DCR-SX33E/SX34E/SX43/SX43E/SX44/ SX44E/SX53E/SX63/SX63E

SERVICE MANUAL

SUPPLEMENT-1

• Deletion of EXPLODED VIEWS

2-1-4. LENS/CHASSIS SECTION

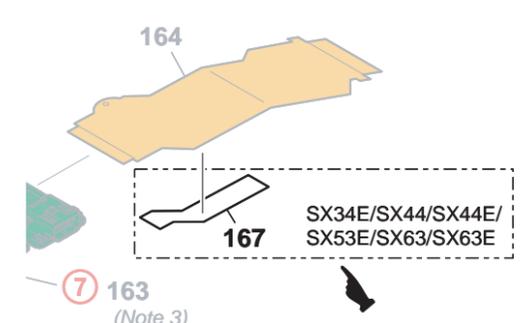
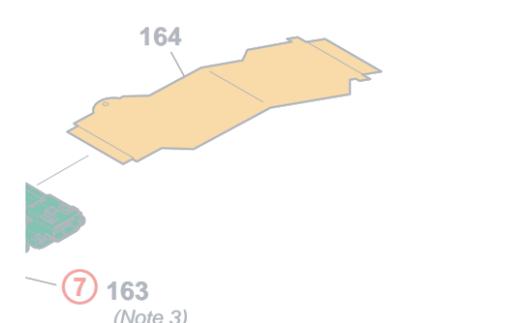
: Points deleted portion

| Page | Former | New | | | | | | | | | | | | |
|----------|--|--|----------|-------------|-----|--------------|--|--|----------|----------|-------------|---|---|---|
| 2-6 |  <p>SX34E/SX44/SX44E/ SX53E/SX63/SX63E</p> <p>⑦ 163 (Note 3)</p> <table border="1"> <thead> <tr> <th>Ref. No.</th> <th>Part No.</th> <th>Description</th> </tr> </thead> <tbody> <tr> <td>167</td> <td>4-181-801-01</td> <td>SHEET (FP1241), RADIATION (SX34E/SX44/SX44E/SX53E/SX63/SX63E)</td> </tr> </tbody> </table> | Ref. No. | Part No. | Description | 167 | 4-181-801-01 | SHEET (FP1241), RADIATION (SX34E/SX44/SX44E/SX53E/SX63/SX63E) |  <p>⑦ 163 (Note 3)</p> <table border="1"> <thead> <tr> <th>Ref. No.</th> <th>Part No.</th> <th>Description</th> </tr> </thead> <tbody> <tr> <td>—</td> <td>—</td> <td>—</td> </tr> </tbody> </table> | Ref. No. | Part No. | Description | — | — | — |
